PERMIT APPLICATION FOR A RESIDENTIAL SITE IMPROVEMENT PERMIT / CONSTRUCTION AUTHORIZATION FOR ON-SITE WASTEWATER SYSTEM NEW WELL INSTALLATION OR REPAIR OF EXISTING WELL MECKLENBURG COUNTY GROUNDWATER & WASTEWATER SERVICES

13608 Sage Thresher

RE: Request for a Revision to Improvement Permit for Lot 173 at The Sanctuary:
MCHD File #5765B

SHEET

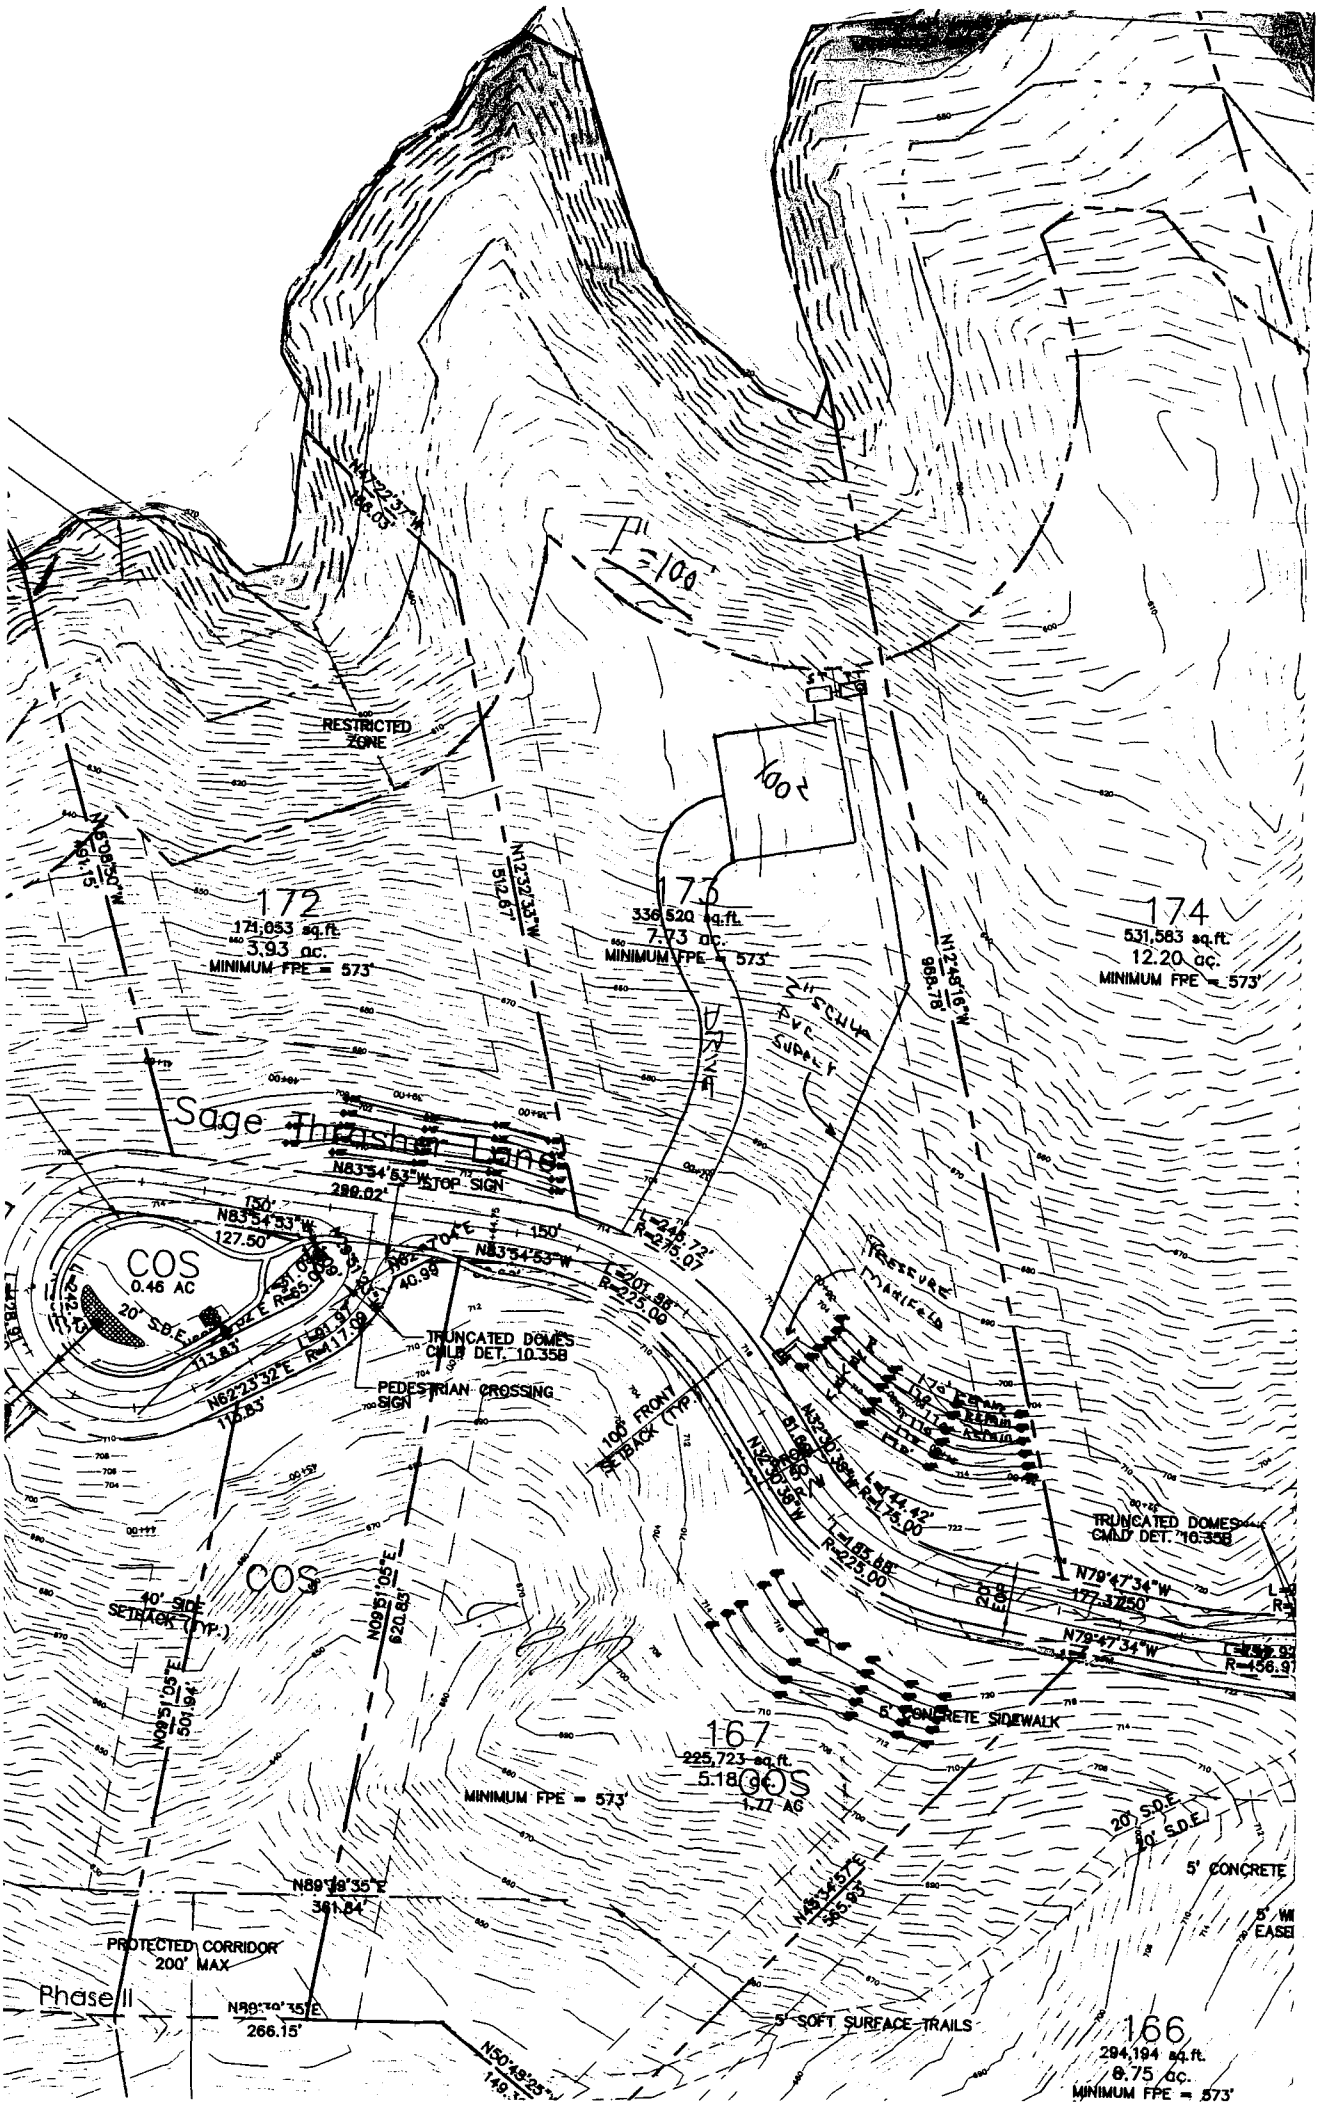
The Sanctuary at Lake Wylie is requesting a revision to the Improvement Permit for the above referenced lot. Mr. Bill Marlin has evaluated the soils (see attached MCHD soil sheets) and S&ME, Inc. has flagged the system and repair on the septic area. The septic lines have been located by the surveyor and are shown on the attached maps. The attached sketch and specifications are not an Improvement Permit and are intended only to assist the MCHD in permitting the referenced lot at The Sanctuary. The only revision being requested is that the developer has moved the proposed drive to the right property line. The drive has been cut in and graveled for a short distance as shown on the attached site plan. The developer did this to aide potential buyers in accessing the lot. The primary system can remain as permitted originally. Addition length was added to the left side of the repair lines to make up for length lost to the new drive. There is additional repair at the area where the drive was originally proposed.
